Attachment B
MARKED-UP TECHNICAL SPECIFICATIONS

DIABLO CANYON - UNITS 1 & 2

Figure 3.4-2
REACTOR COOLANT SYSTEM HEATUP LIMITATIONS - APPLICABLE UP TO 8 EFPY

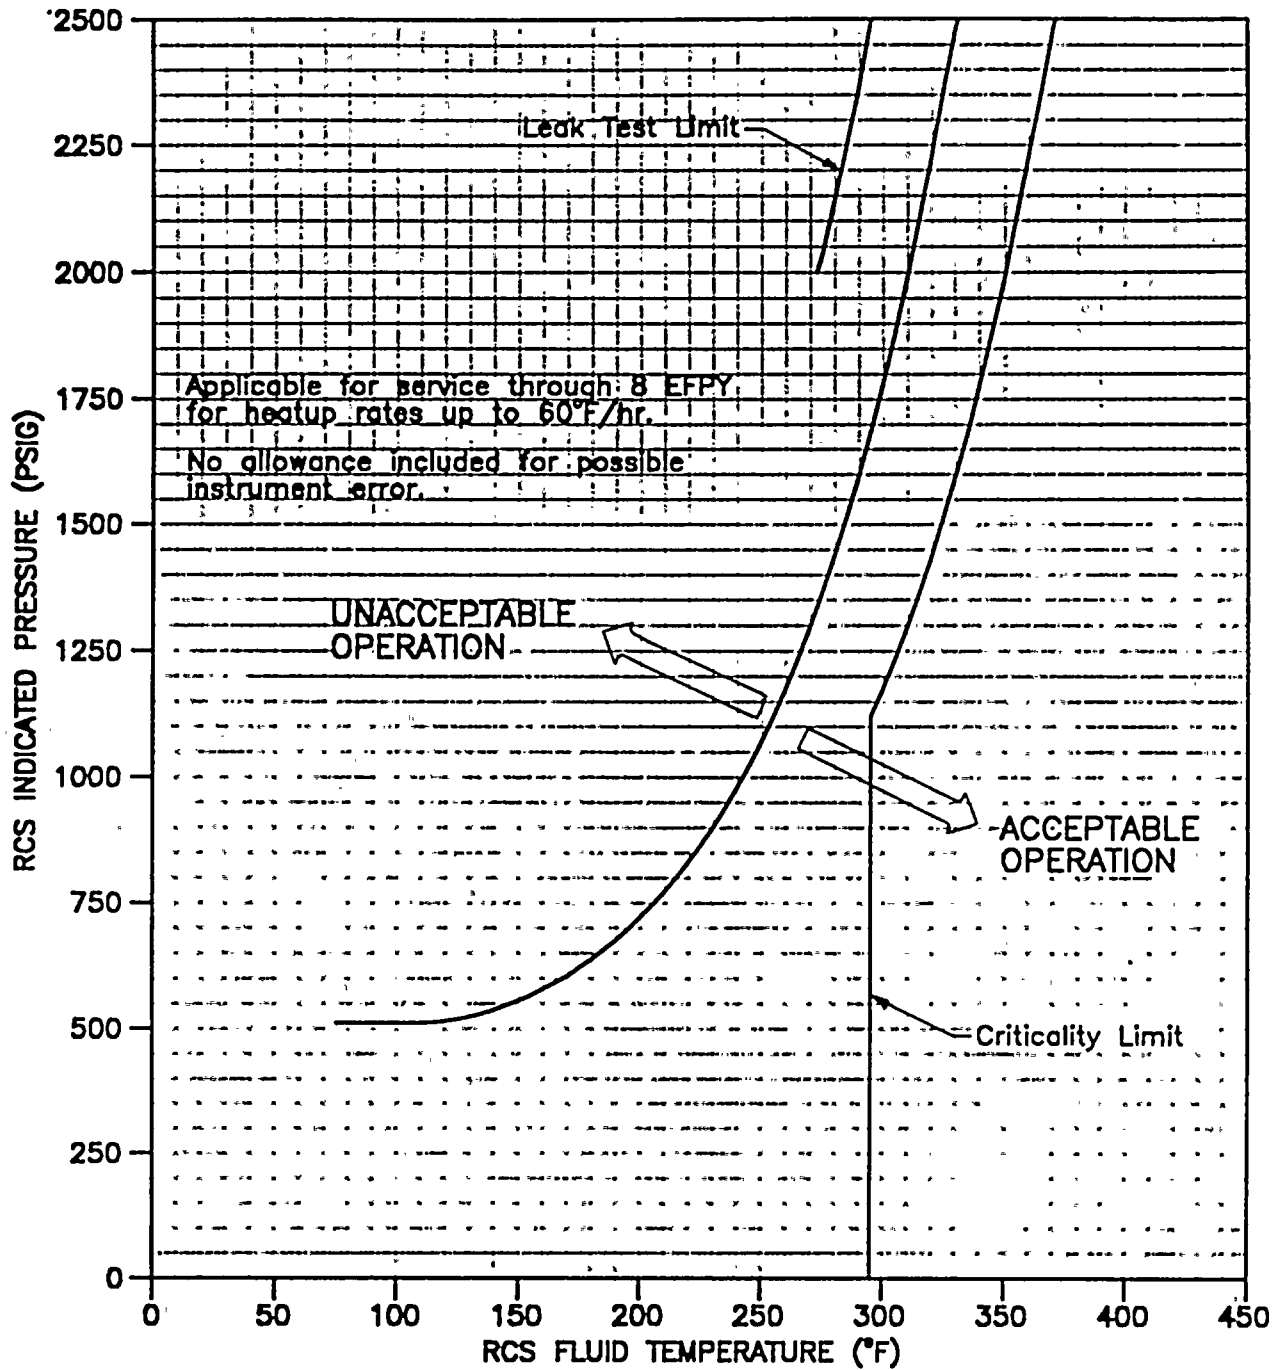
Unit 2 Intermediate Shell Plate B5454-2 0.14wt.% Cu 0.59wt.% Ni

Initial $RT_{NDT}=67^{\circ}F$ Projected RT_{NDT} $1/4T = 164^{\circ}F$ $3/4T = 141^{\circ}F$

Figure 3.4-3
REACTOR COOLANT SYSTEM COOLDOWN LIMITATIONS - APPLICABLE UP TO 8 EYPY

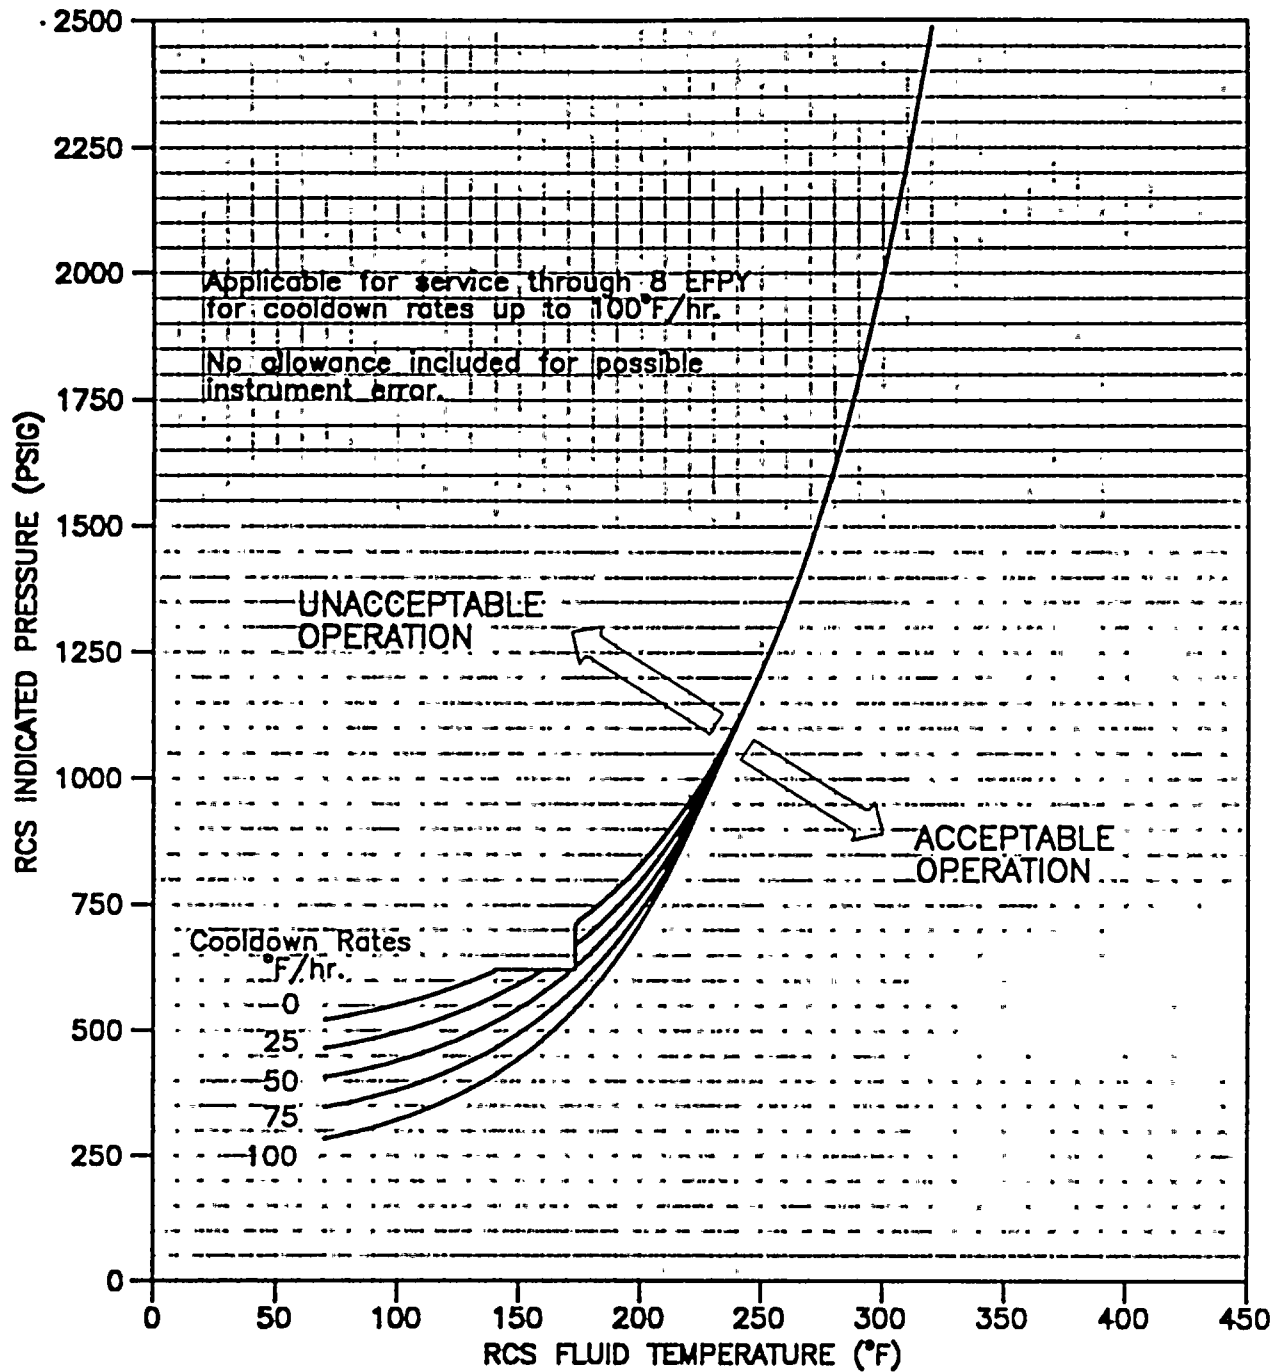
Unit 2 Intermediate Shell Plate B5454-2 0.14wt.% Cu 0.59wt.% Ni

Initial $RT_{NDT}=67^{\circ}\text{F}$ Projected RT_{NDT} $1/4T = 164^{\circ}\text{F}$ $3/4T = 141^{\circ}\text{F}$

FIGURE B 3/4.4-1
FAST NEUTRON FLUENCE (E>1 MeV) AS A FUNCTION OF FULL POWER SERVICE LIFE

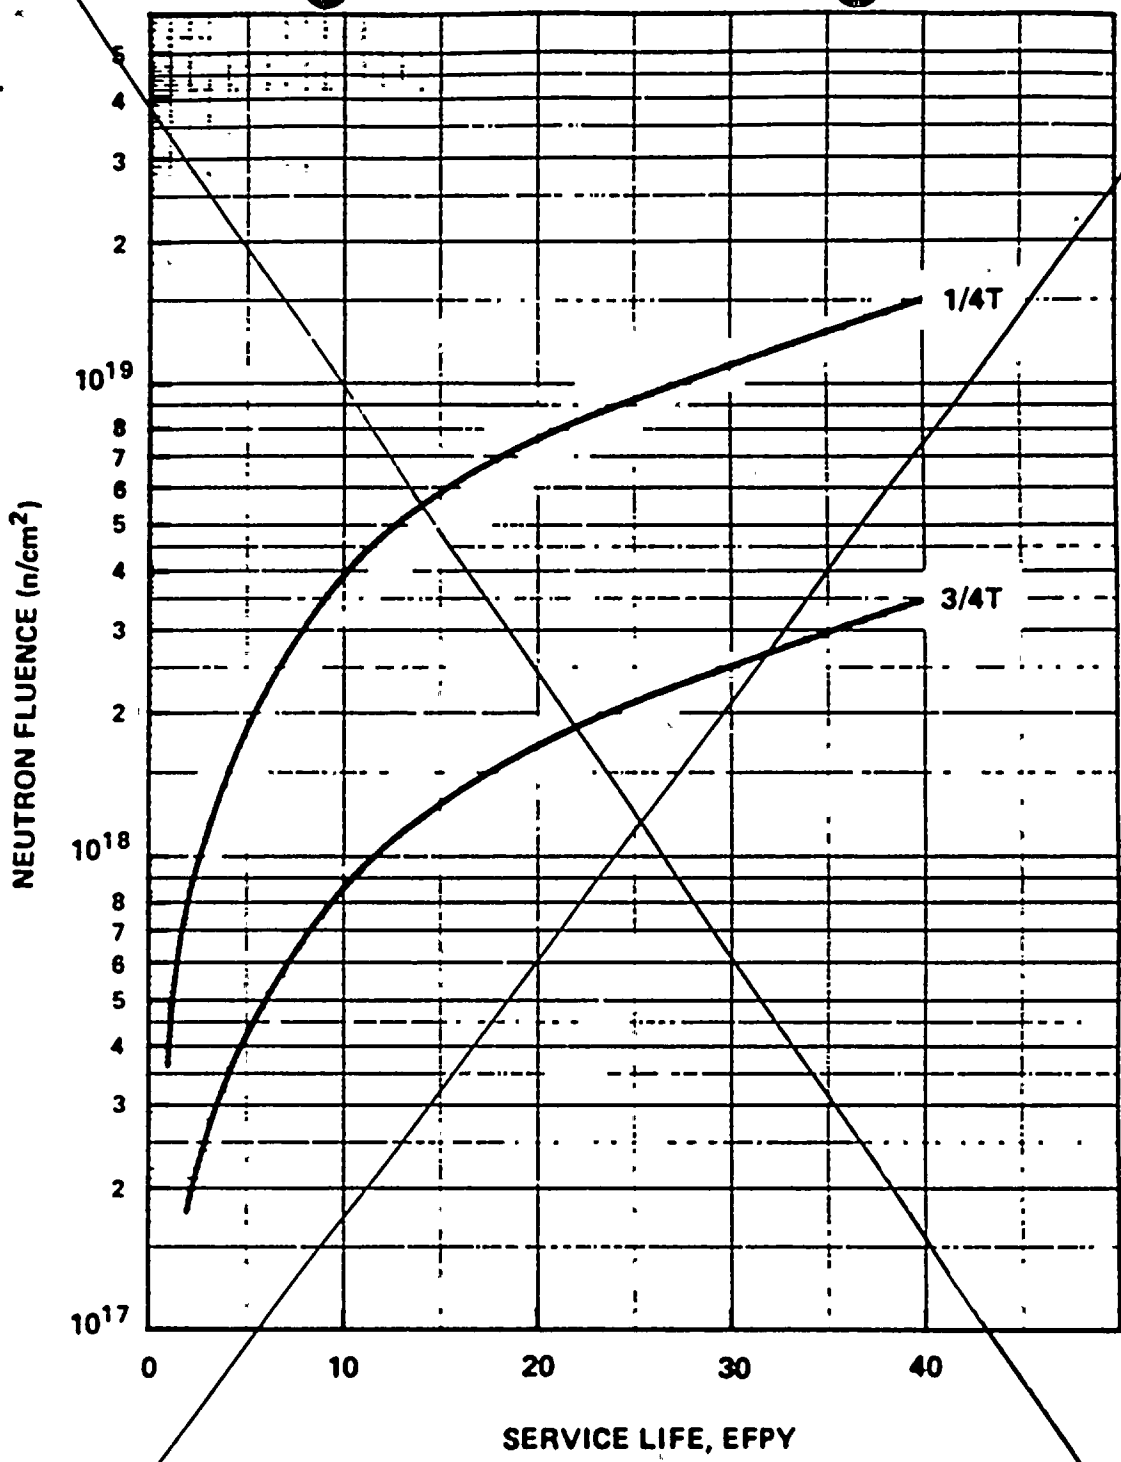
DELETE

FIGURE B 3/4.4-2

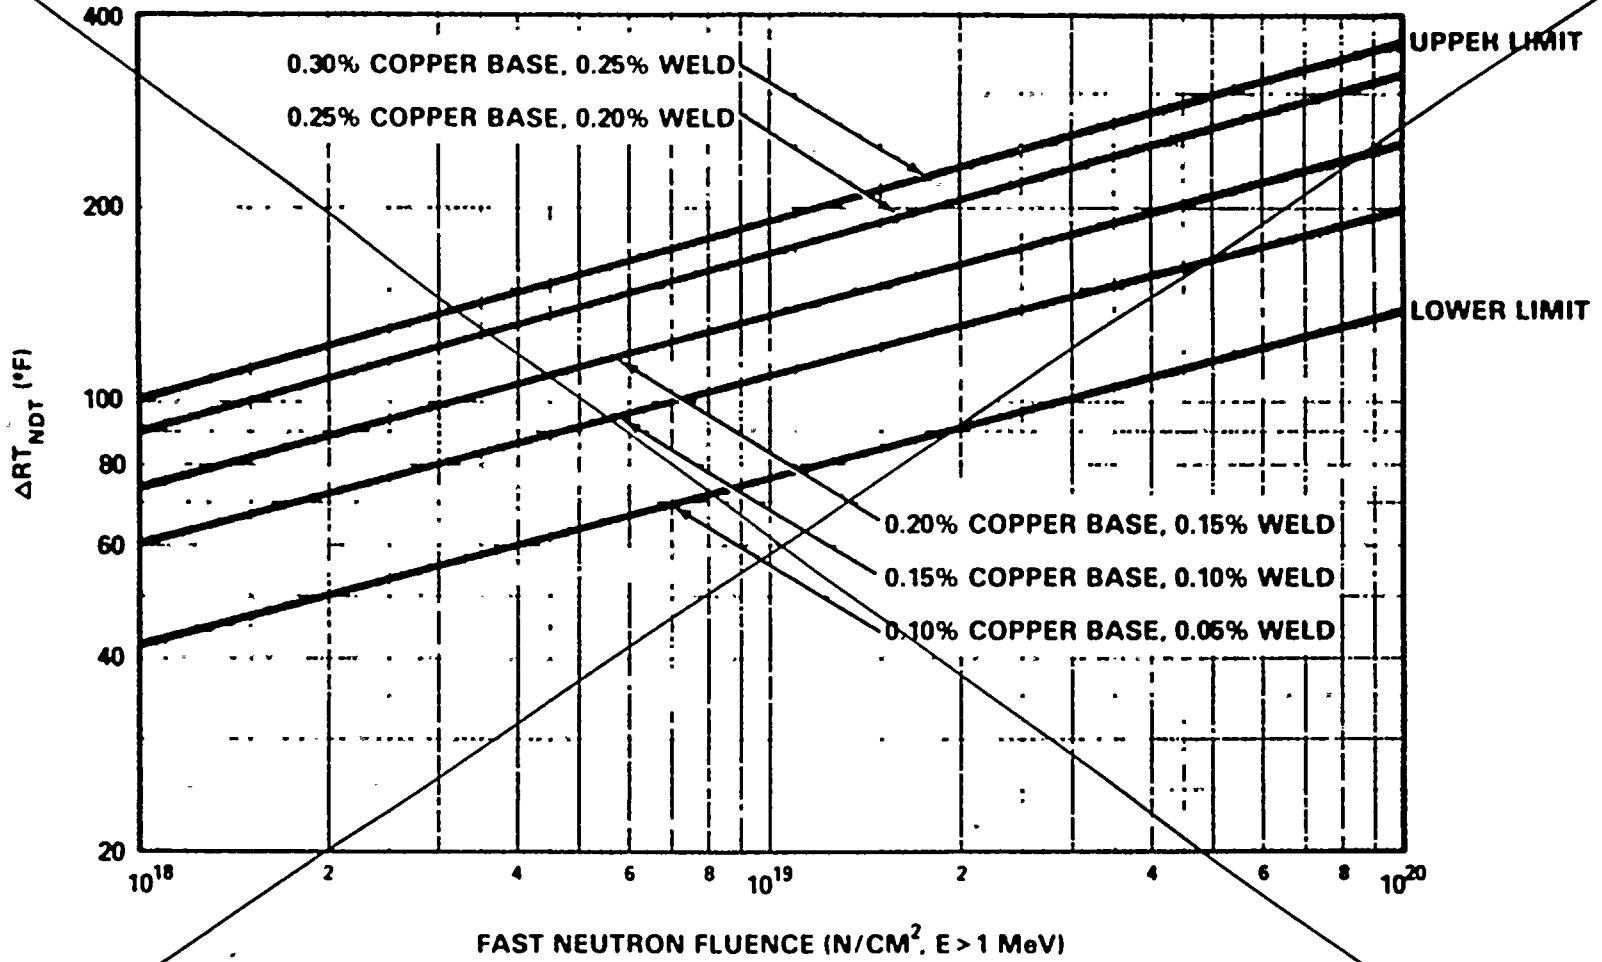
DELETE
